PROJECT NAME: WAITSFIELD
PROJECT NUMBER: BRF 013-4(39)
FILE NAME: z12b136+yp.dgn
PROJECT LEADER: R. YOUNG
DESIGNED BY: D. KULL
TYPICAL SECTIONS SHEET 1
PLOT DATE: 10/13/2015
DRAWN BY: S.MERKWAN
CHECKED BY: T. KENDRICK
SHEET 9 OF 69

TYPICAL BRIDGE SECTION
SCALE 3/8" = 1'-0"

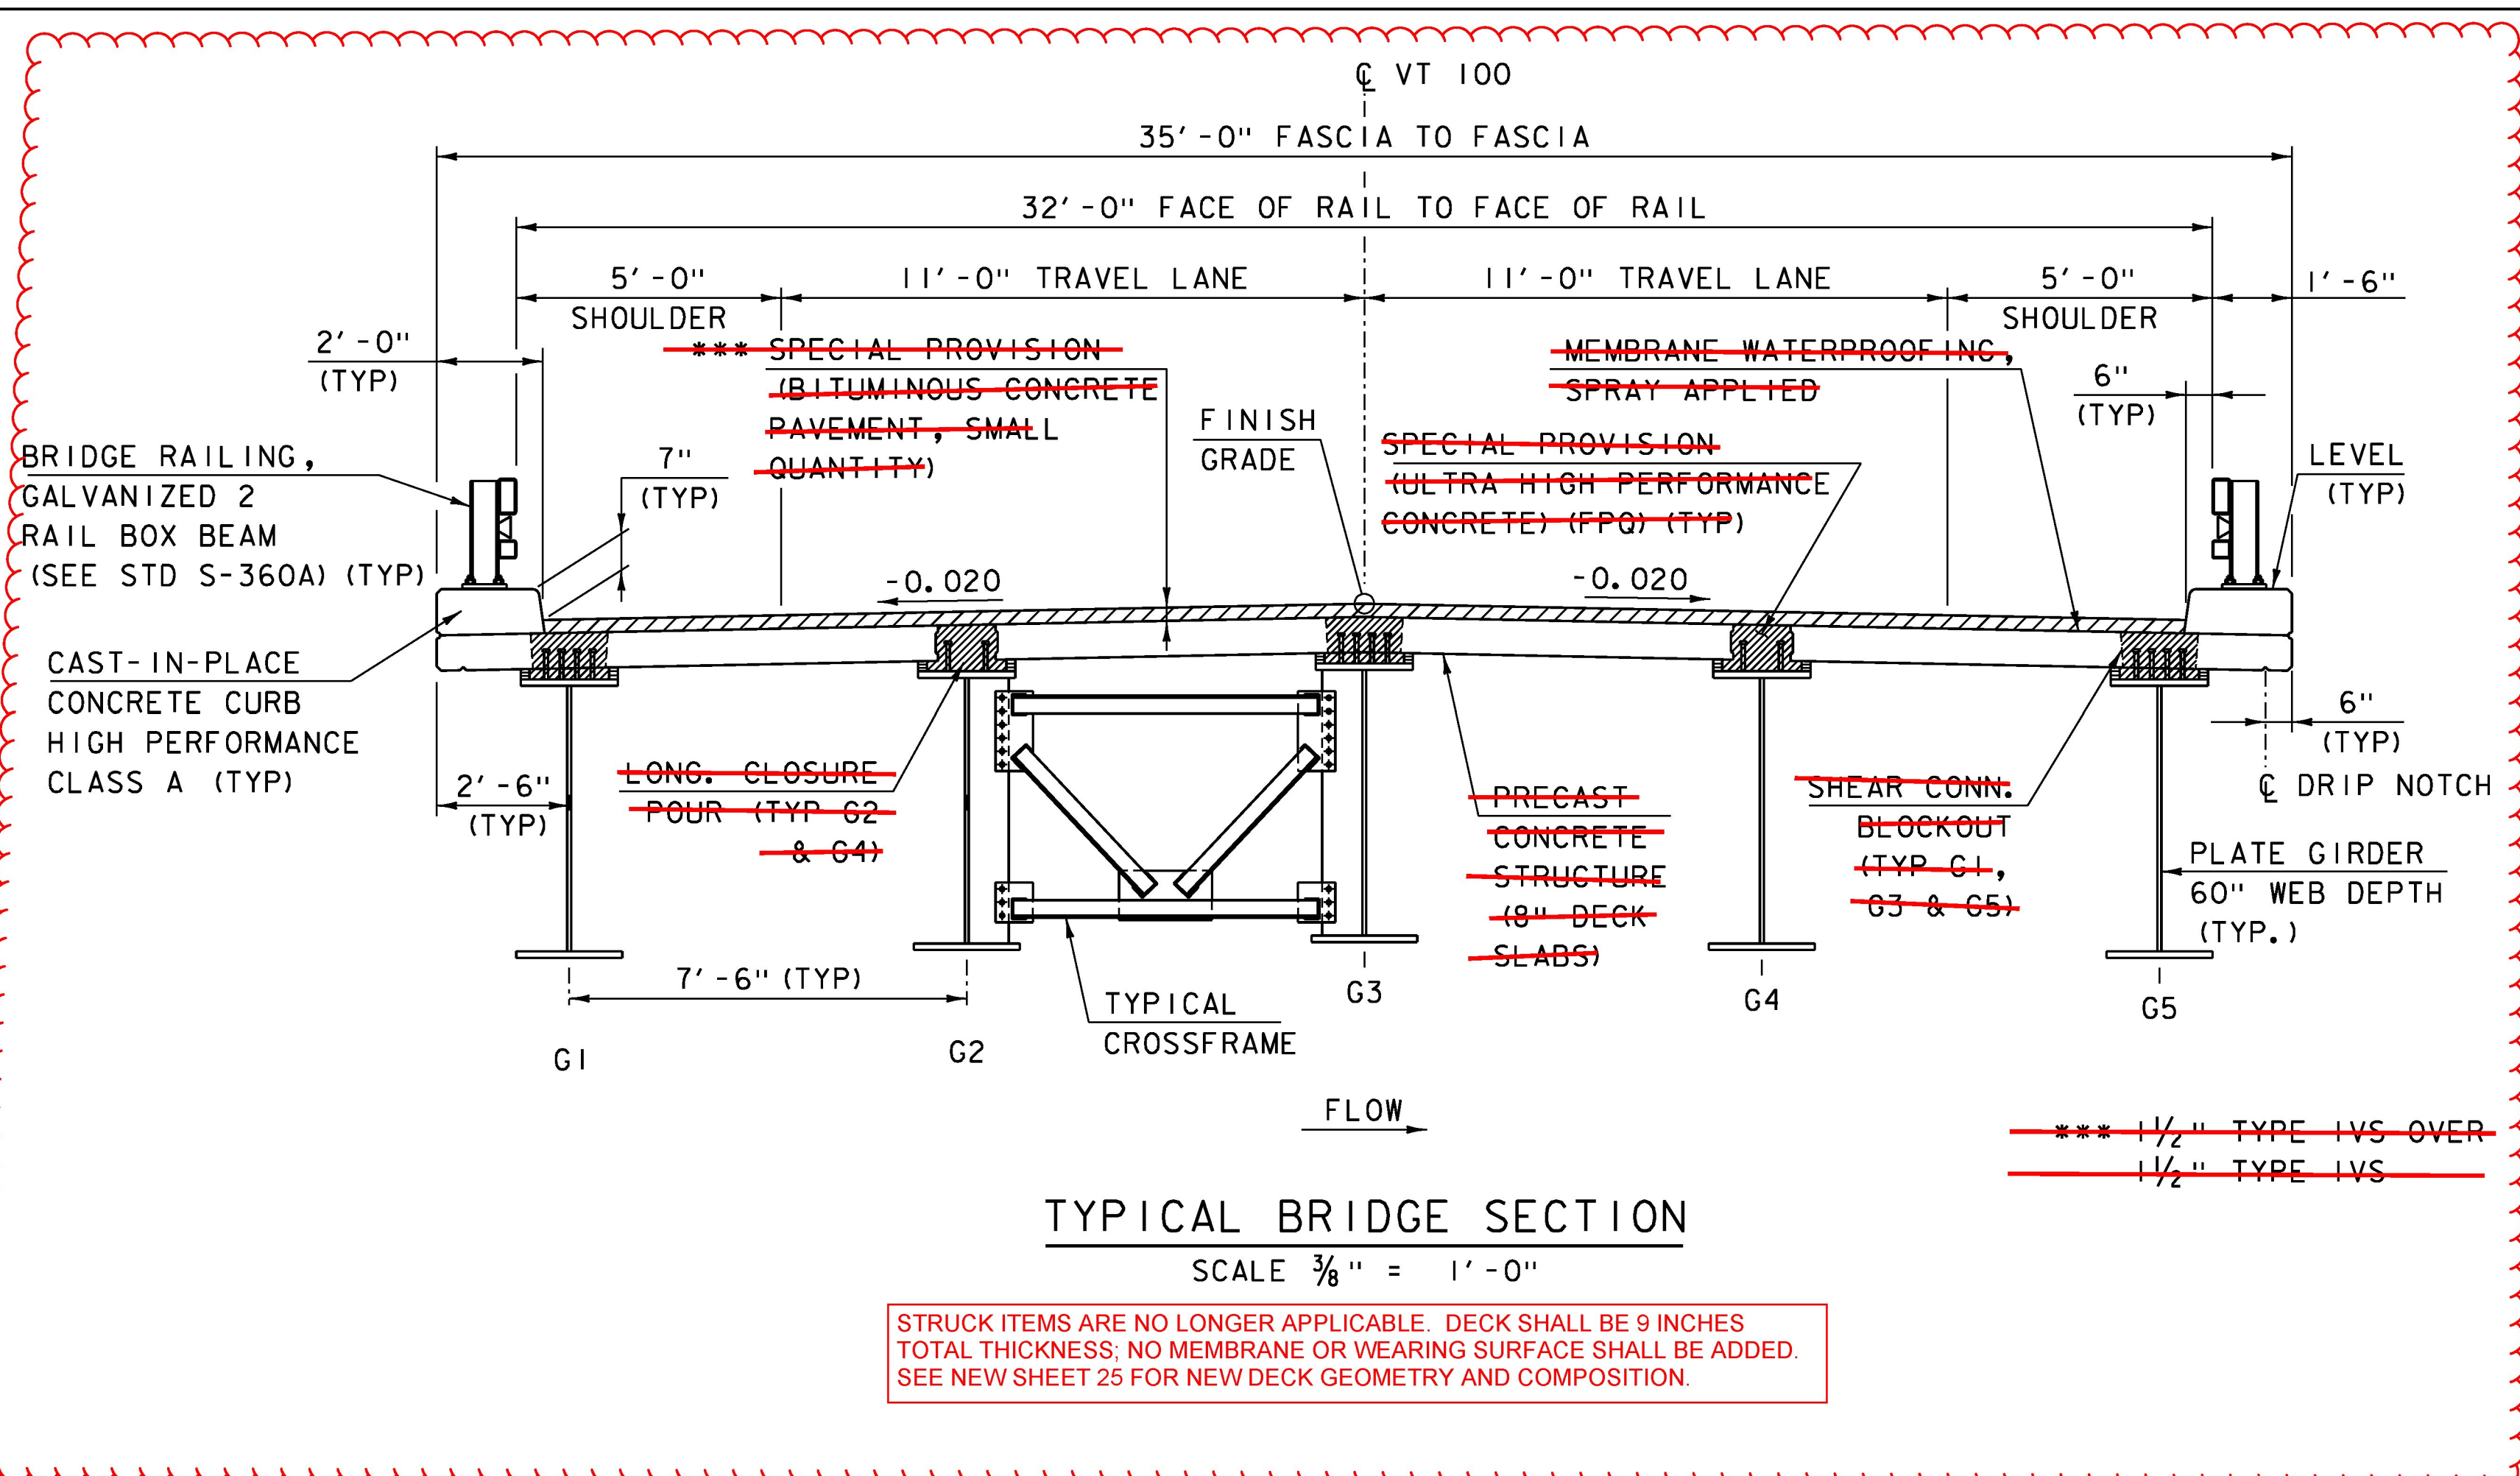
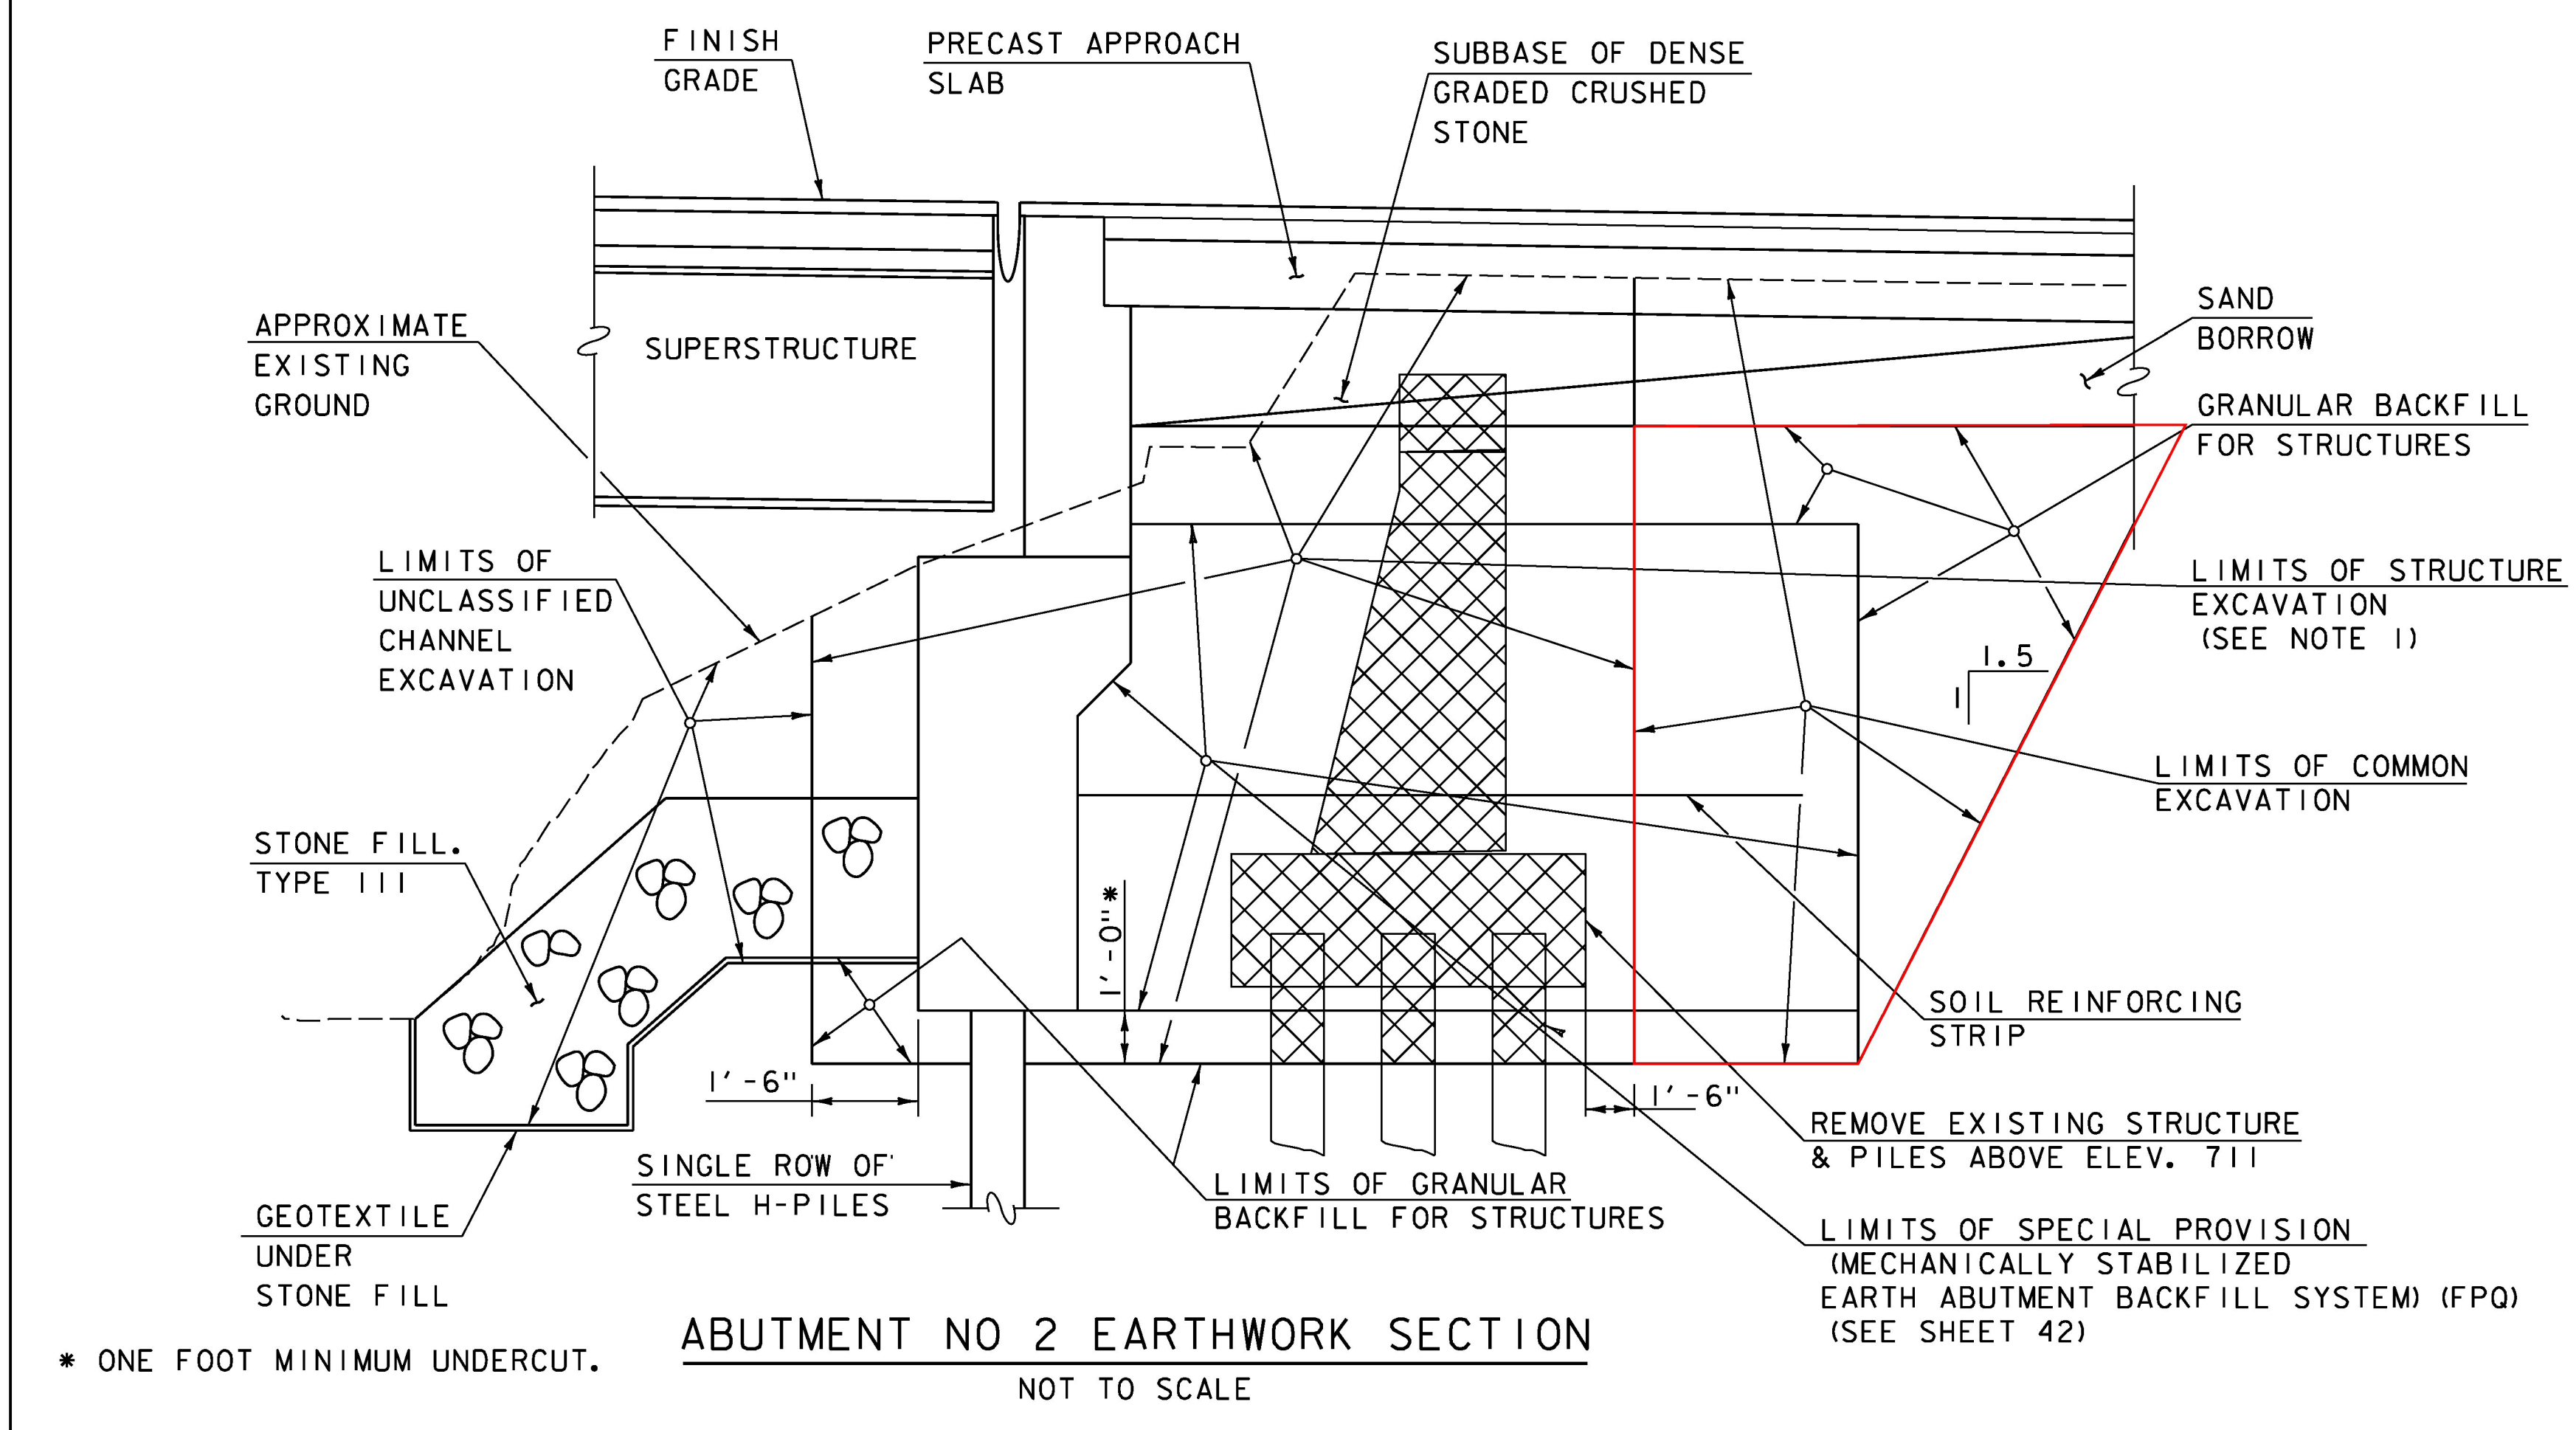
STRIKED ITEMS ARE NO LONGER APPLICABLE. DECK SHALL BE 9 INCHES TOTAL THICKNESS. NO MEMBRANE OR WEARING SURFACE SHALL BE ADDED. SEE NEW SHEET 25 FOR NEW DECK GEOMETRY AND COMPOSITION.
